**Plan Commission Agenda**  
**Monday, March 16, 2026 - 6:00 PM**  
**Lake Geneva City Hall; Council Chambers**

STAFF REPORT  
To Lake Geneva Plan Commission  
Meeting Date: March 16, 2026

1724 W. Main St.  
Tax Key No. ZA522000001  
Planned Development – Precise  
Implementation Plan

**Dining Commons Location (from Civil Engineering Plans Sheet 05)**

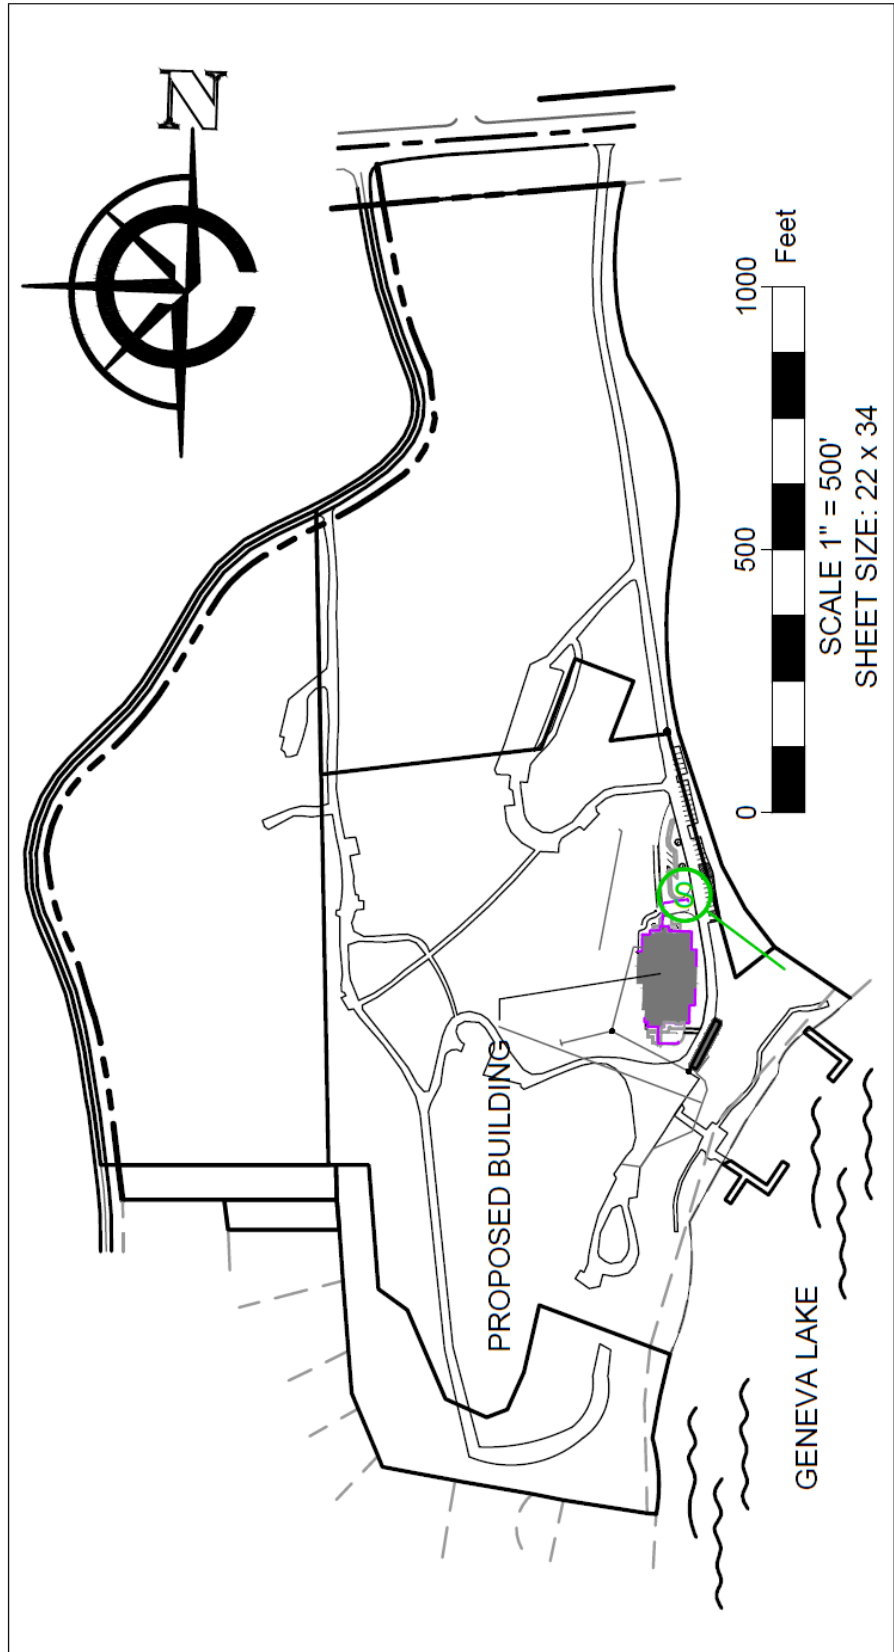
The dining facility (“Dining Commons”) will be a new 16,785-square-foot building to be used as a dining hall and indoor lounge space for campers. It will replace “The Lodge,” a 76-year-old building that includes both a dining hall and 52 beds. These beds will not be replaced in the new dining hall. Other improvements include windows with lake views, outdoor patios with seating, a lakeside café, and an enhanced camper drop-off and vehicle turnaround. The Dining Commons will be located on the southeast side of the camp, near the lakefront, as seen on the map on the following page.

The Site Plan includes a redesigned access drive on the north side of the Dining Commons. This is primarily used for loading and camper drop-off and allows for adequate vehicle turnaround. The access drive will include three new parking spaces as well. Dumpsters for the Dining Commons will be located in the existing parking area to the north east of the building. The proposed dumpster enclosure will include stone and wood siding intended to blend into the surrounding environment.

Staff recommends that the Plan Commission recommend *approval* of the PIP as submitted.

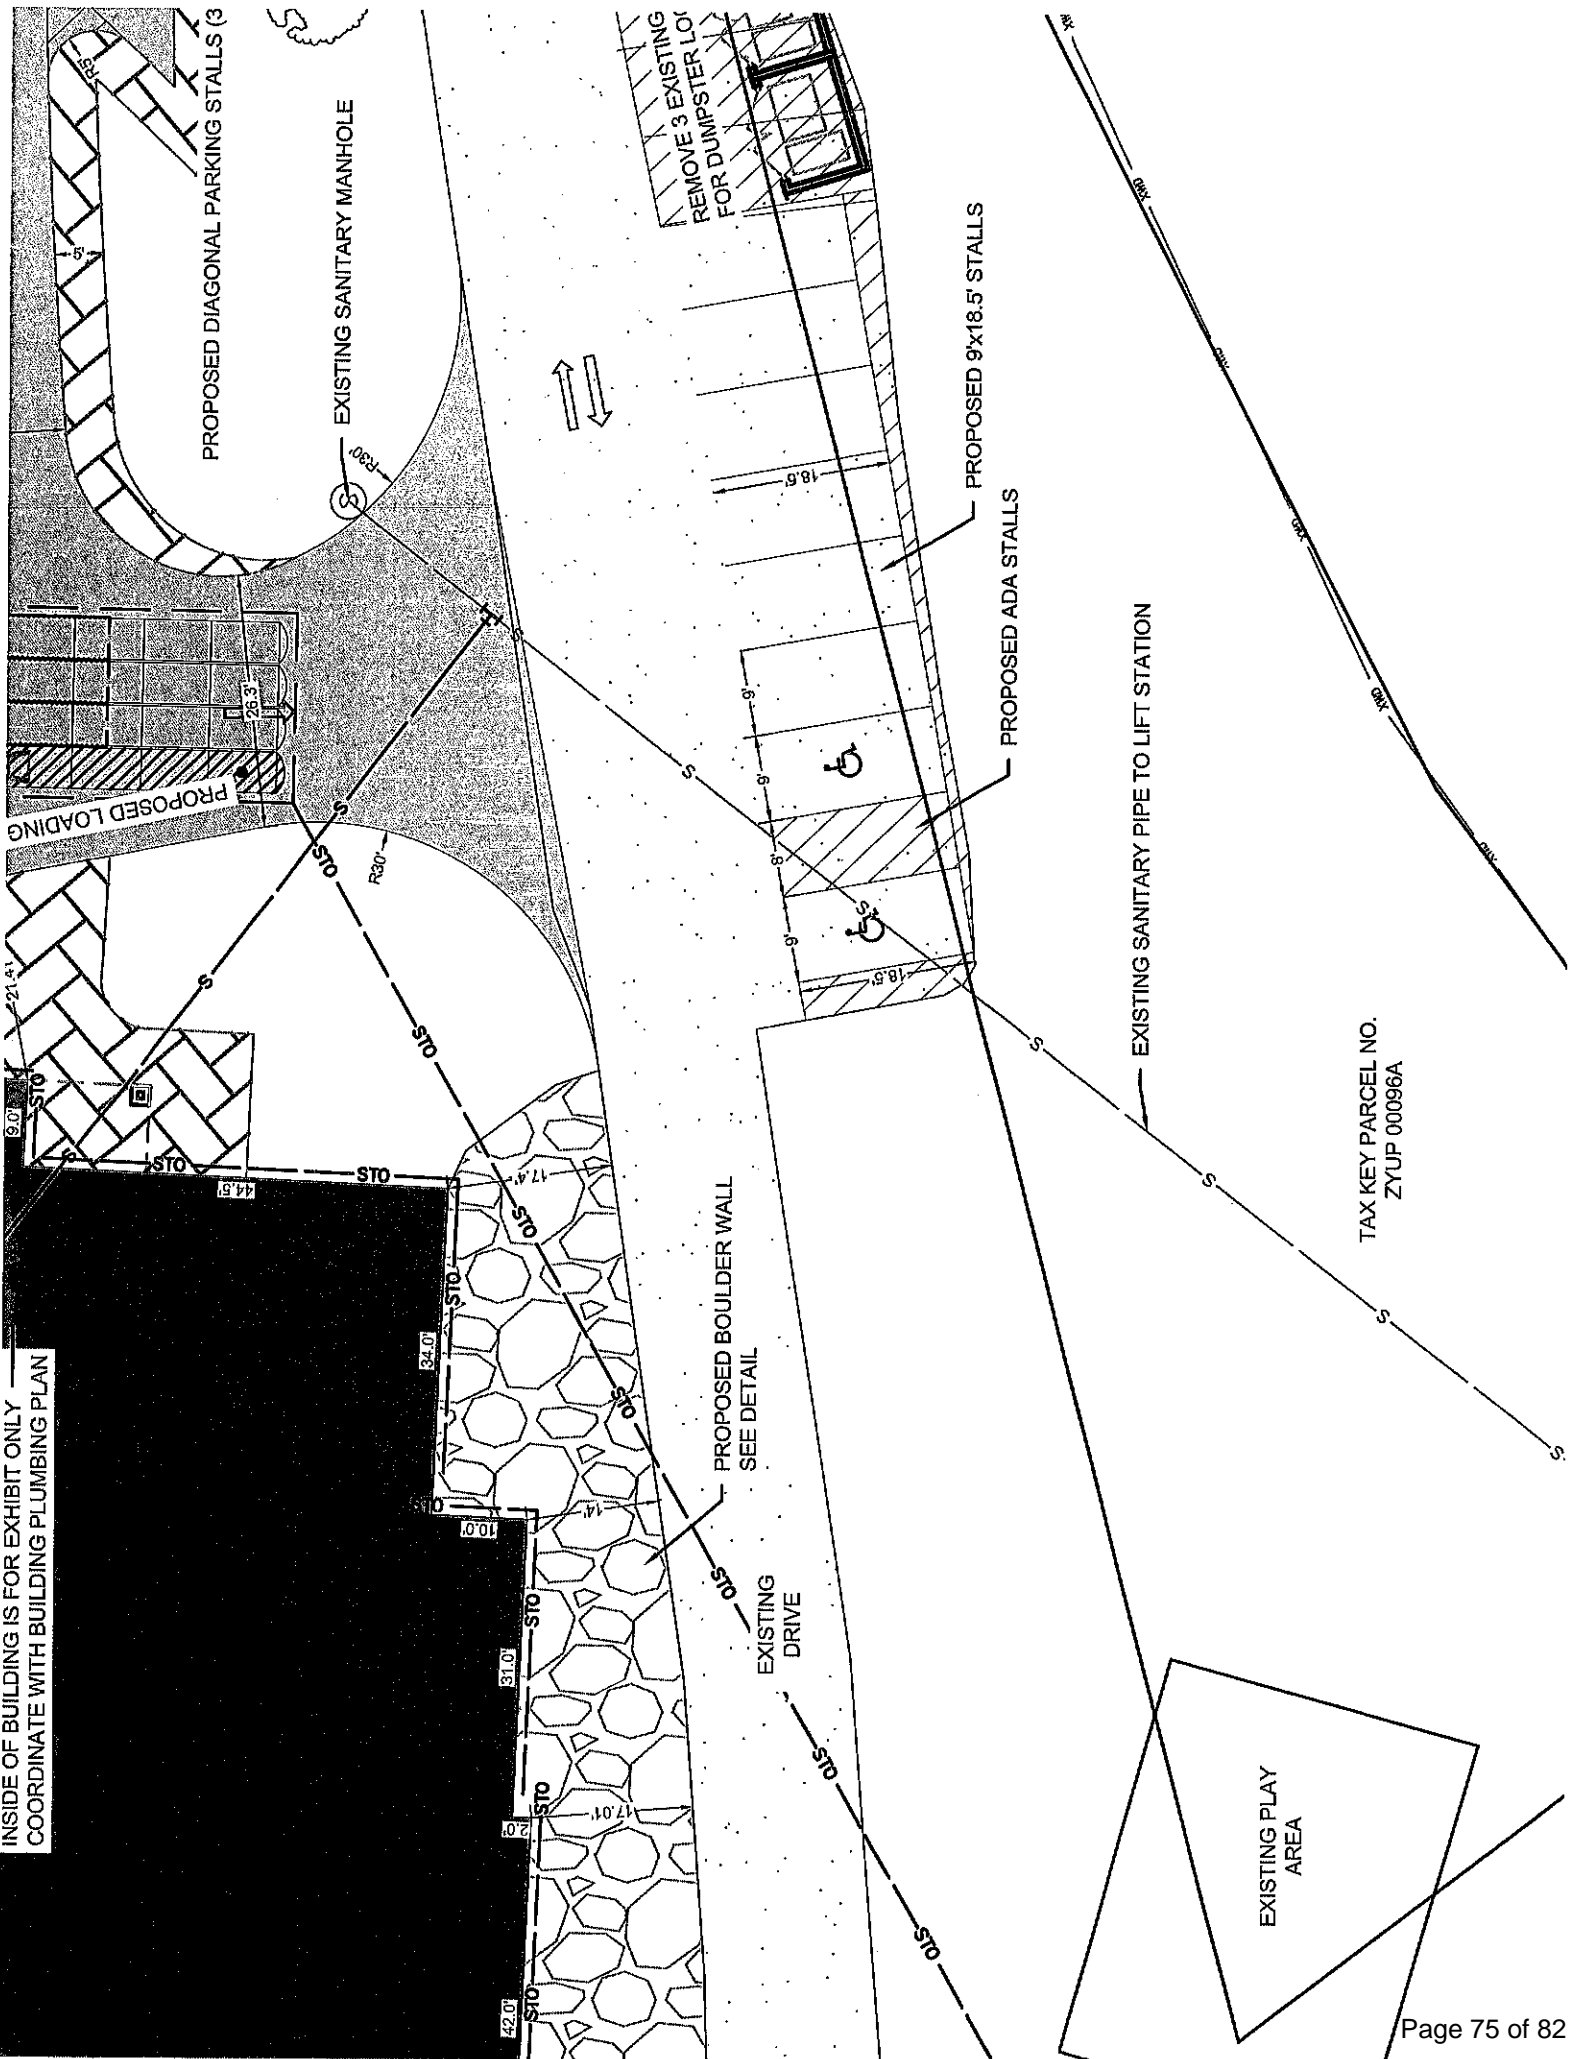
1. Sanitary sewer from C0-1 to WYE-1 does not meet frost protection requirements of Wisconsin Plumbing Code SPS 382.30. The plans shall be revised to show the appropriate depth or insulation per the state code.
